PALADIN ENERGY CORP.

Re: Request to Clarify Well Construction
Paladin Energy Corp., South Vacuum 274 Well (30-025-37122)
Order No. SWD-1444

RE: SWD-1444; South Vacuum Well No. 274 (API 30-025-37122)

PRESENT COMPLETION 5/5/2015

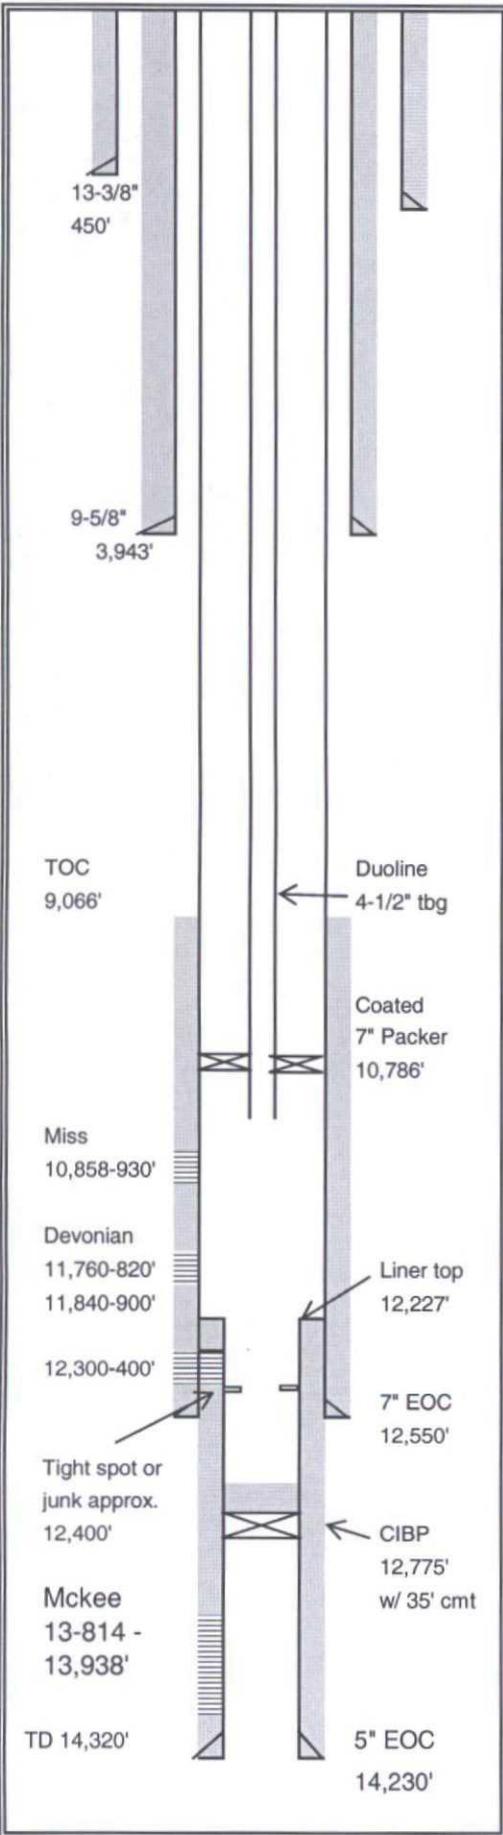
Accordingly the existing filings with the Division fail to reflect that since injection operations began in 2013, a CIBP at 12,775' along with the 35' of cement exists to maintained mechanical integrity, isolate the Mckee perforations, and ensure that all disposed fluids are injected into the permitted Devonian and Mississippian perforations. To address these reporting errors I have enclosed (a) the pertinent daily records from our files, (b) amended C-103's that Paladin intends to file with the Division to more accurately reflect the operations in 2007 and 2013, and (c) a revised well schematic that shows the current configuration of the South Vacuum Well No. 274.

Additionally, the operator is requested to clarify a well construction item for the conversion of the South Vacuum Well No. 274 to a SWD well. Both the proposed well design in the C-108 application for the SWD order and the APD submitted to District dated December 18, 2013, identify a CIBP (with cement cap) to be placed at approximately 12635 ft. The C-103 filed on December 19, 2013, does not note the installation. Please verify the installation of the CIBG and provide a current well completion diagram showing the final construction along with copies of the appropriate daily reports. Please contact me (phone or e-mail) with any questions regarding this matter. PRG

Thank you for the immediate response to my request. The information you provided on May 6th addressed all the questions I had regarding the conversion of the SVU No. 274 to a SWD well. The completion information shows that the well's final completion satisfies the intent stipulated in the SWD order (minimal distance of casing below the lowest perf). This information will be included in the SWD order image file to avoid any future questions on the final construction. PRG
